Appendix A: Consultation Record

407 TRANSITWAY - KENNEDY ROAD TO BROCK ROAD

MINISTRY OF TRANSPORTATION - CENTRAL REGION

**RE: 407 Transitway from east of Kennedy Road to east of Brock Road
Planning and Preliminary Design Study G.W.P. 13-20003
City of Markham and City of Pickering**

Schematic Service Diagram

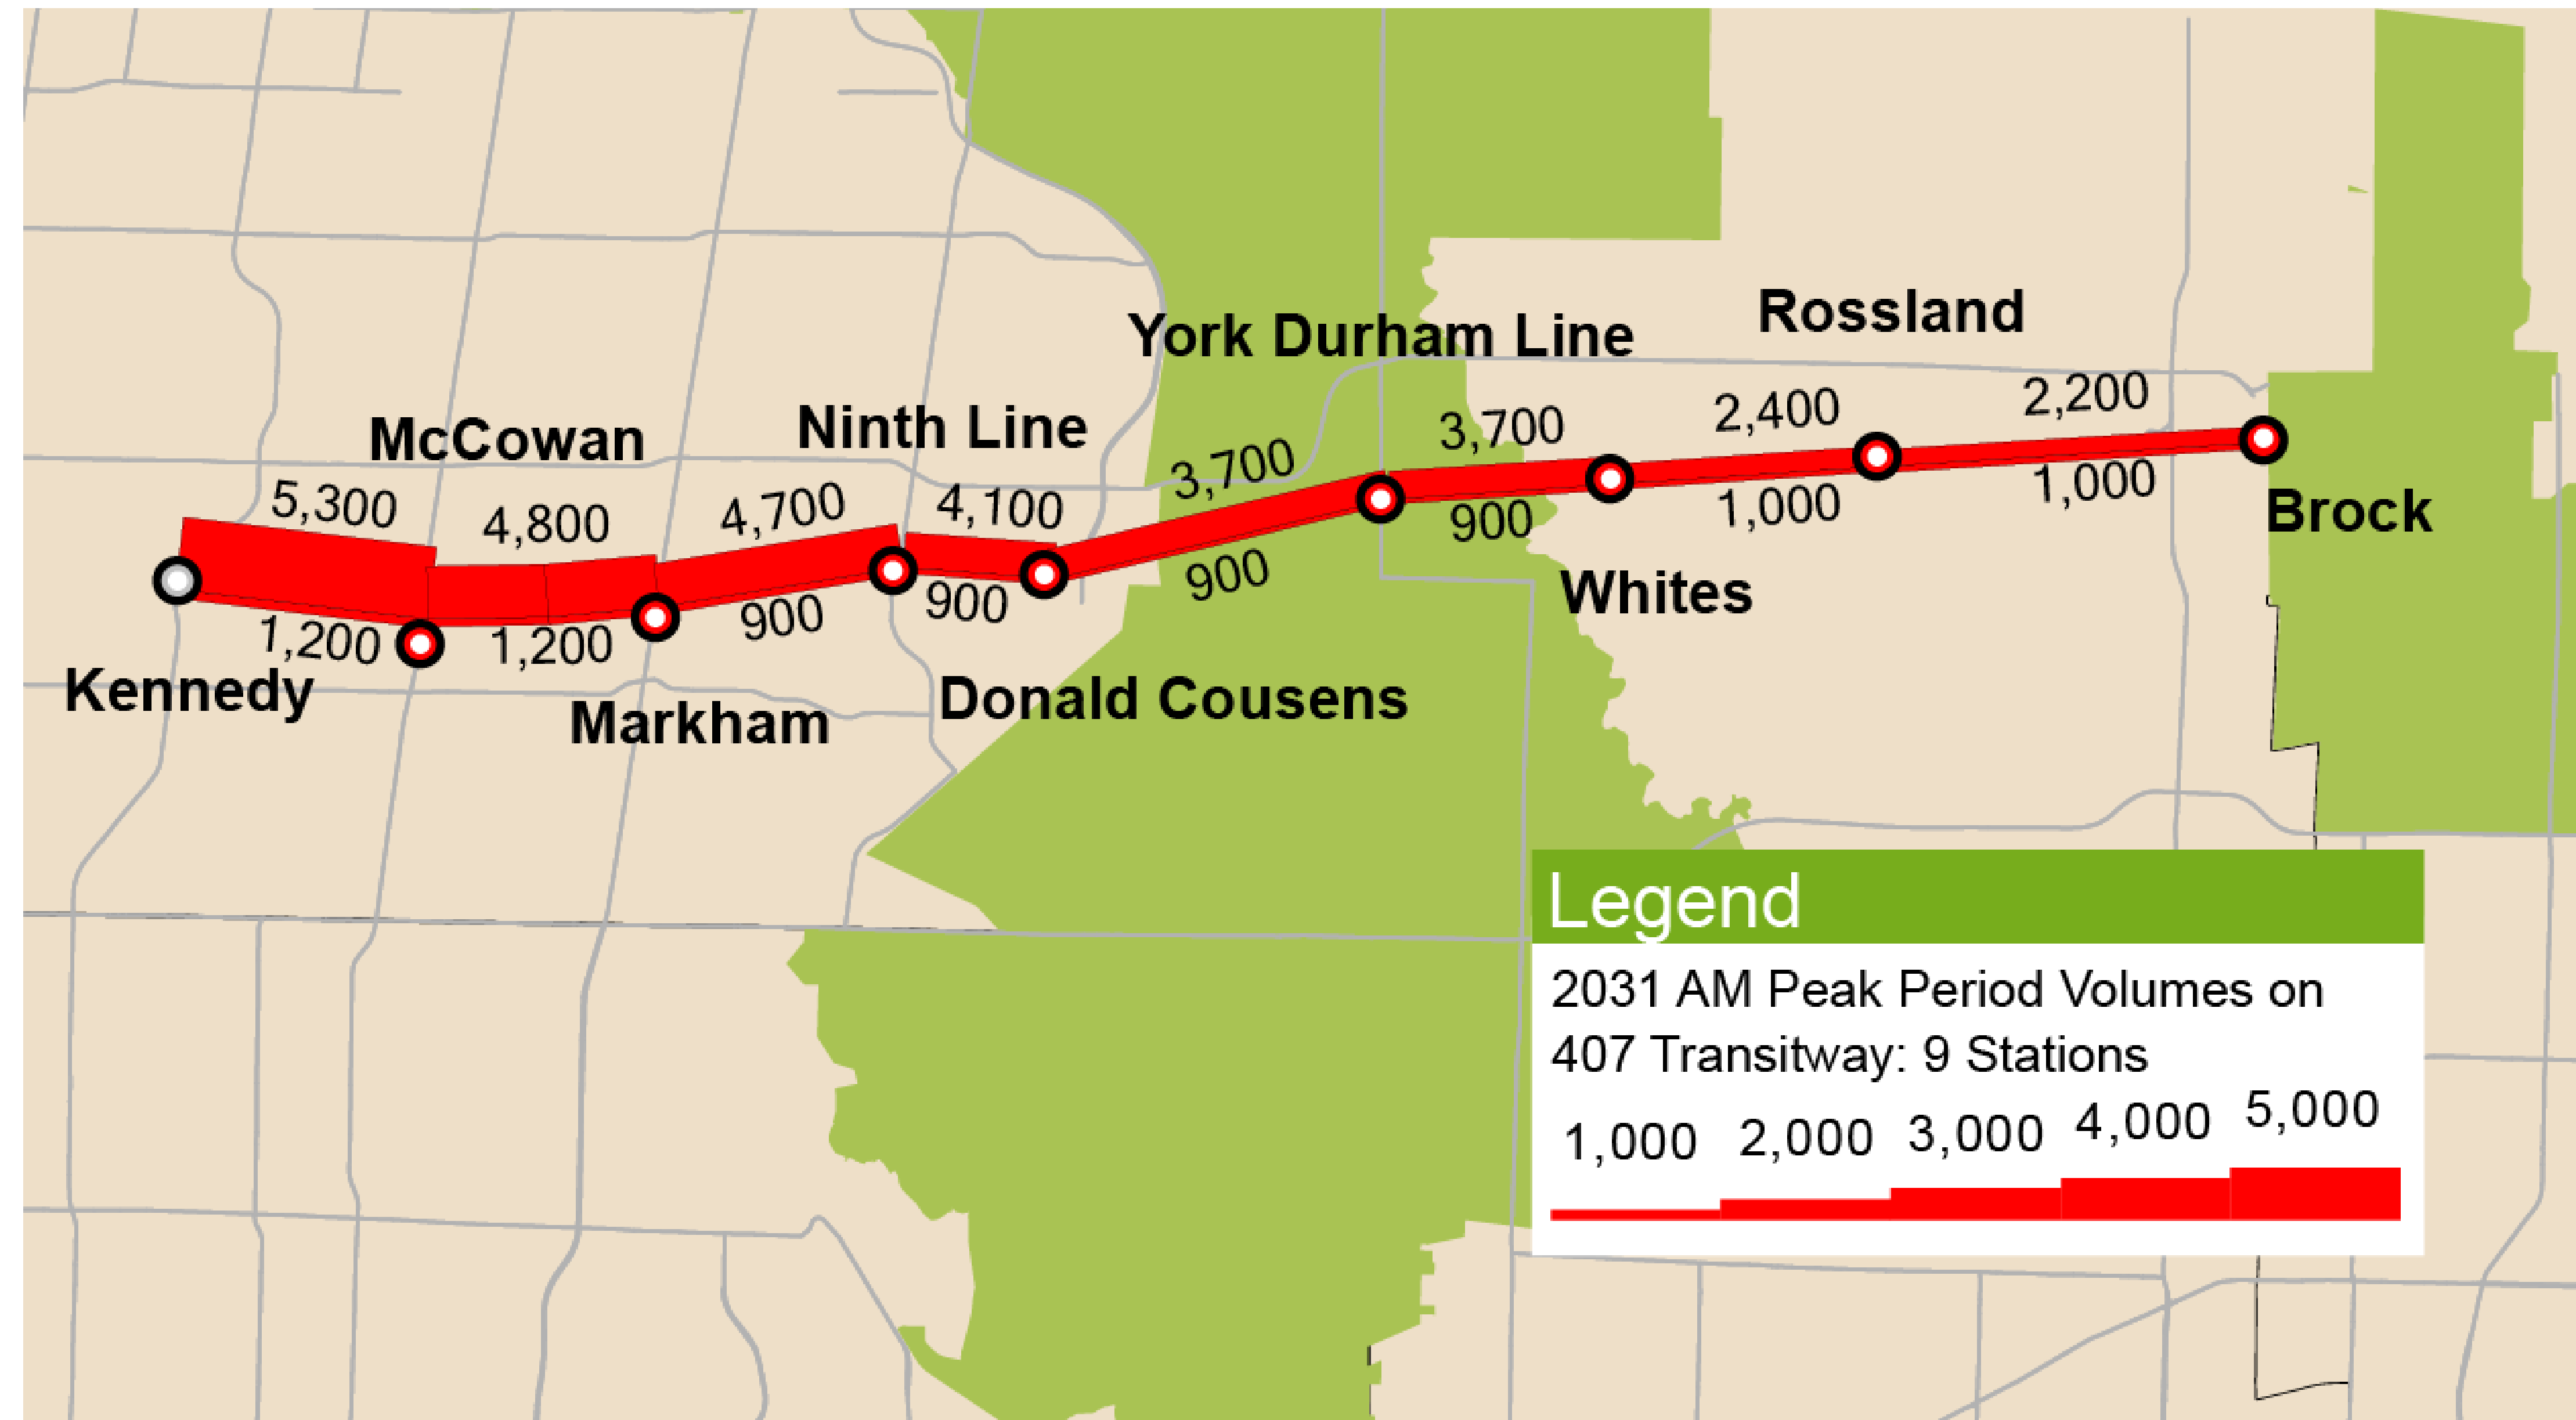
9. Section 2.3.2 (page 2-10) describes that the majority of riders entering the Transitway at Brock Road and Whites Road station will access via no-transfer services and cites buses will come from Pickering UGC, Brooklin and Oshawa. It should be noted that Figure 2.4 shows these routes as “Base Spine Services” opposed to “No Transfer Services.” Please ensure consistency in the report when referring to routes/route structure.
